PROJECT SCOPING PLAN FOR PERFORMING A
CERCLA REMEDIAL INVESTIGATION/FEASIBILITY
STUDY (RI/FS) AT THE MUNITIONS WASHOUT FACILITY
AND LEACH FIELD, SENECA ARMY DEPOT ACTIVITY

OCTOBER 1996

**PROJECT SCOPING PLAN
REMEDIAL INVESTIGATION/FEASIBILITY STUDY
AT SEAD-4
SENECA ARMY DEPOT ACTIVITY
ROMULUS, NEW YORK**

**Parsons Engineering Science, Inc.
Prudential Center
Boston, Massachusetts**

FIGURE 4-2
**PROPOSED SURFACE WATER AND
 SEDIMENT SAMPLE LOCATIONS**

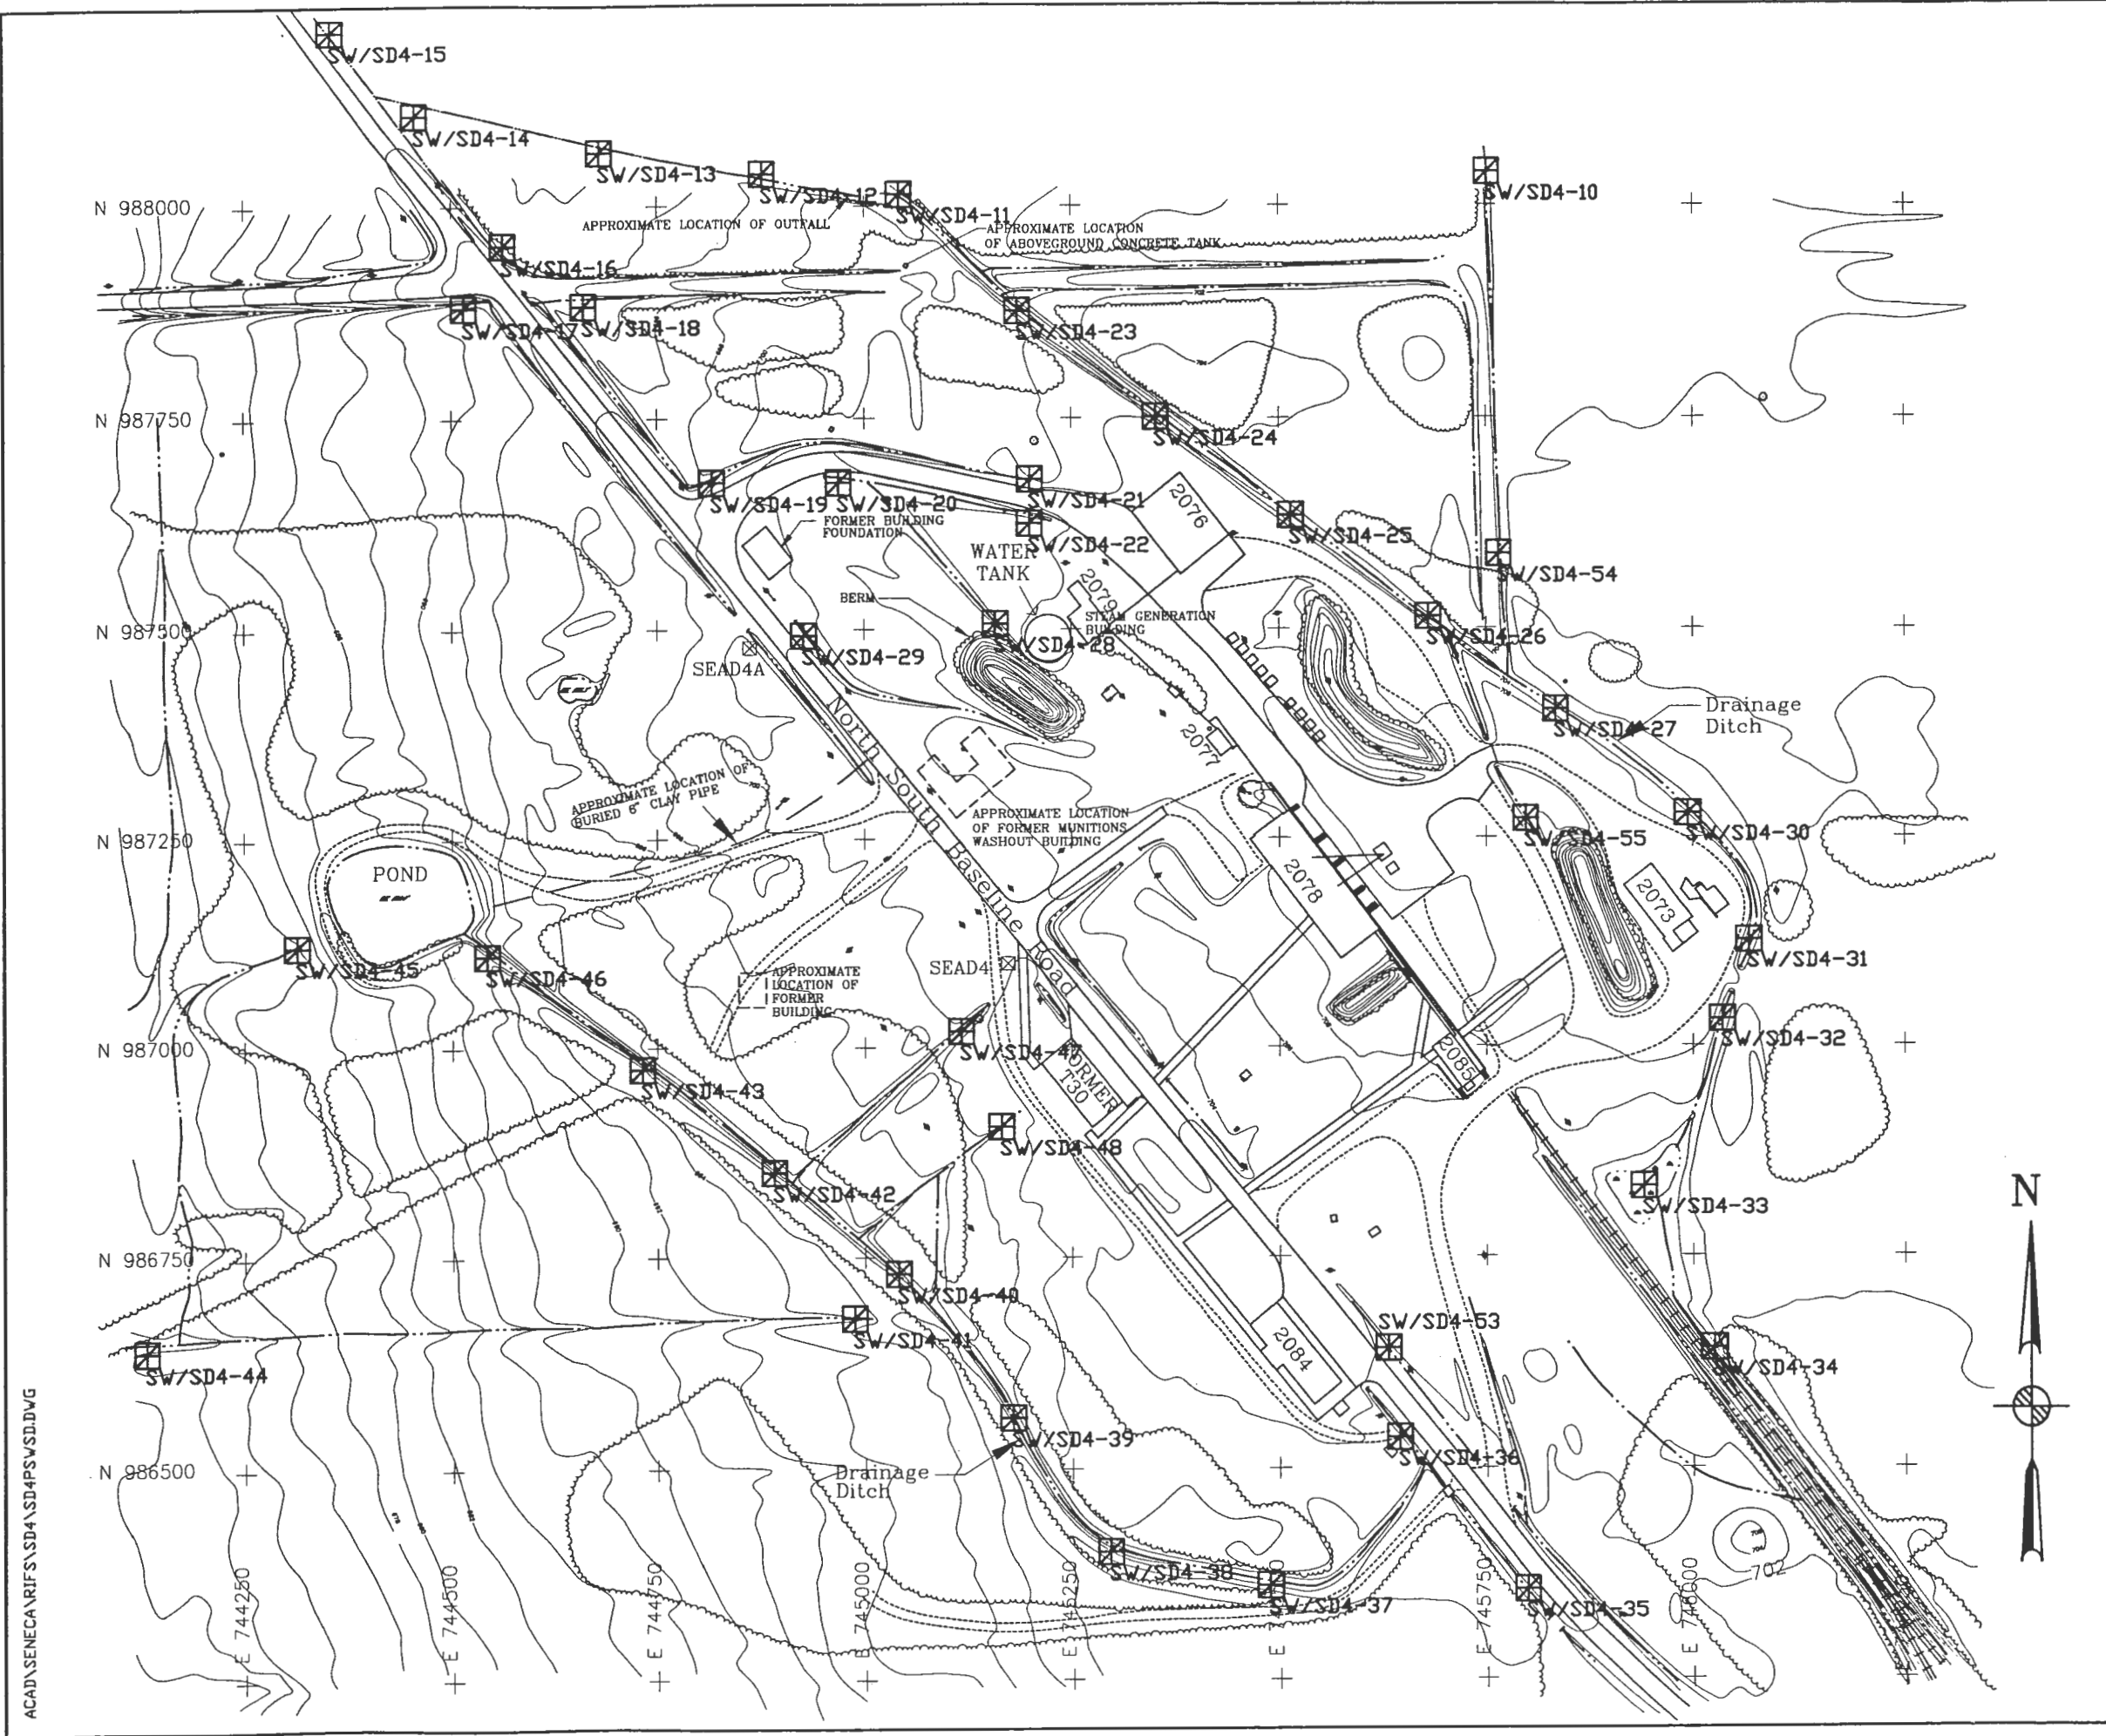
- Response #12** Agreed. The discrepancy on page 4-7 has been corrected.
- Comment #13** Figure 4-2: It appears as if the proposed sediment/surface water sampling location SW/SD4-30 is for all practical purposes the same as the sediment sampling location SD4-5 from the ESI. If this is the case, then there is no reason to recollect a sediment sample. Although the work plan text concludes on page 3-5 that it is unlikely that wastewater was discharged from Building 2084, there is conflicting information on this point. Because of this it may be warranted to collect a sediment sample from the drainage which is located to the northeast of Building 2084.

- Figure 3-6 indicates that surface water flow in the drainage ditch to the northeast of Building 2073 divides approximately 300 feet downgradient from Building 2073. Figure 4-2 concentrates the sediment/surface water

- Comment #13** Although Parsons ES agreed with this comment and responded that the sample locations for SW/SD 4-49, SW/SD 4-50, and SW/SD 4-51 would be included on Figure 4-2, a revised version of Figure 4-2 has not been provided.

Agreed. Two additional sample locations were added. Additional sample locations have been added to the north-south trending arm of the drainage ditch (SW/SD4-50), and to the northwest-southeast trending drainage ditch that drains from the berm west of Building 2073 (SW/SD4-51). The changes in the SEAD-4 Scoping Plan were made on page 4-8 and Figure 4-2.

- Response #13** Acknowledged. The response to comment letter incorrectly stated these three surface water/sediment sample location IDs as SW/SD4-49, SW/SD4-50, and SW/SD4-51, however, the samples locations were added to the Figure 4-2; their numbers are SW/SD4-53, SW/SD4-54, and SW/SD4-55. Figure 4-2 was revised and the recommended sample locations are shown on the revised figure. Therefore, no change was made to Figure 4-2.

FIGURE 4-2 (continued)
 PROPOSED OFF-SITE
 SURFACE WATER AND SEDIMENT
 SAMPLING LOCATIONS

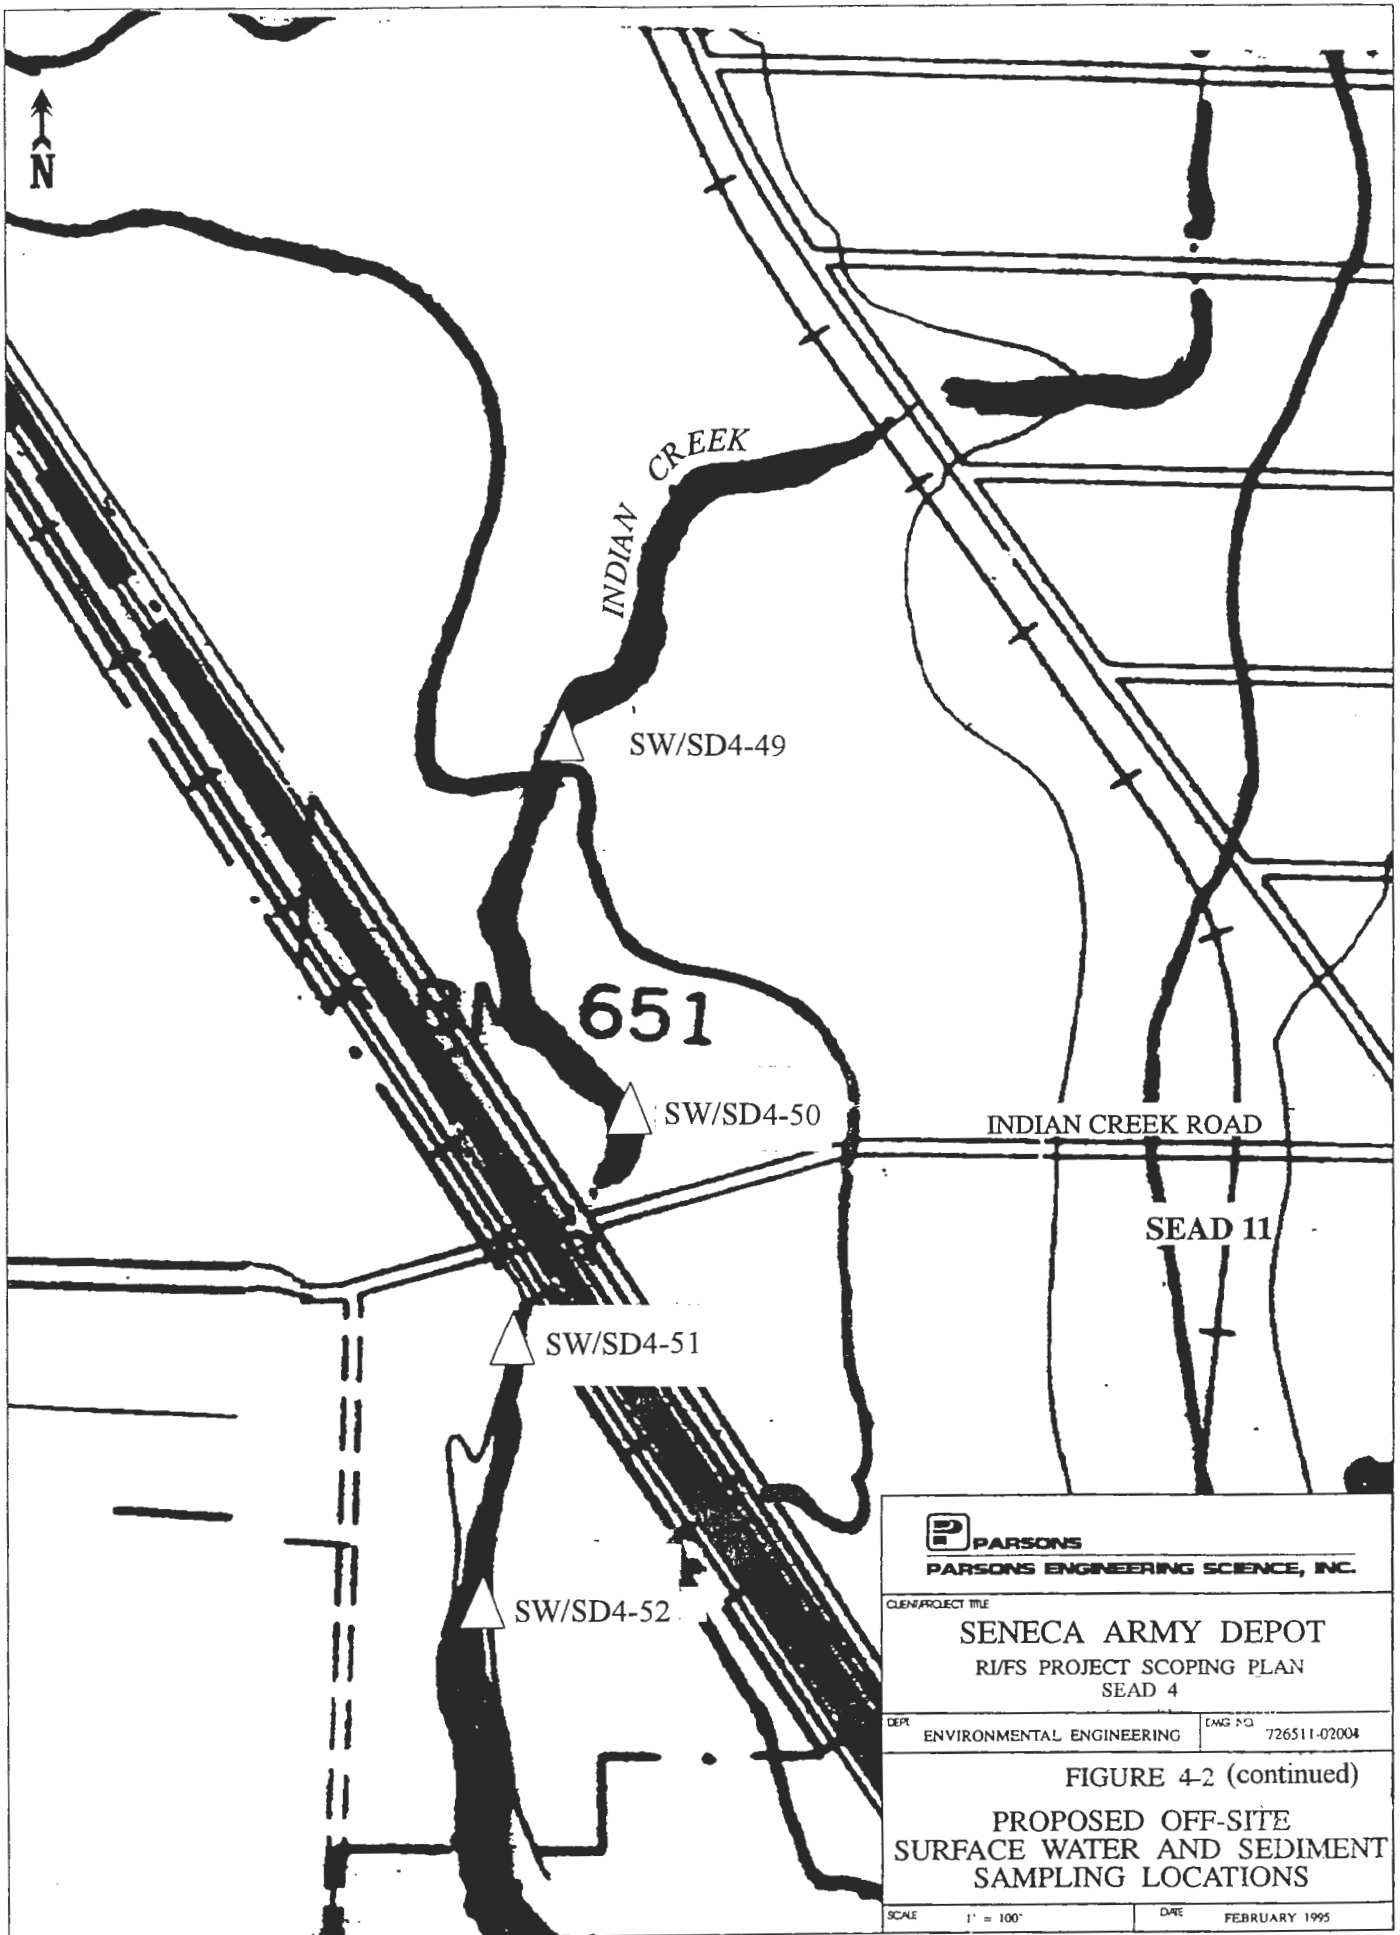
- Comment #1** Figure 4-2 (continued) illustrates the locations of four sampling points, two upstream of Indian Point Road and two downstream from the Road. It is unclear why Indian Point Road was chosen to delineate between upstream and downstream points. The location of SEAD-4 should be provided in this figure, along with the location of the drainage ditch and any discharge points into the Creek. In the future RI/FS Report for SEAD-4, topographic figures indicating surface water drainage should also be provided to illustrate the flow of wastewater and stormwater towards the Creek. Sampling should be conducted in depositional areas.
- Response #1** Agreed. This is because it was reported by former SEDA employees that while the washout facility was in operation approximately 100 gallons of wastewater were discharged to Indian Creek; it was reported to have been

SEAD-4 was not included on Figure 4-2 because of scale restrictions. However, to provide a frame of reference for the reader text has been added to page 4-8 of the SEAD-4 Scoping Plan that states that SEAD-4 is located approximately 600 feet east of sample location SW/SD4-51.
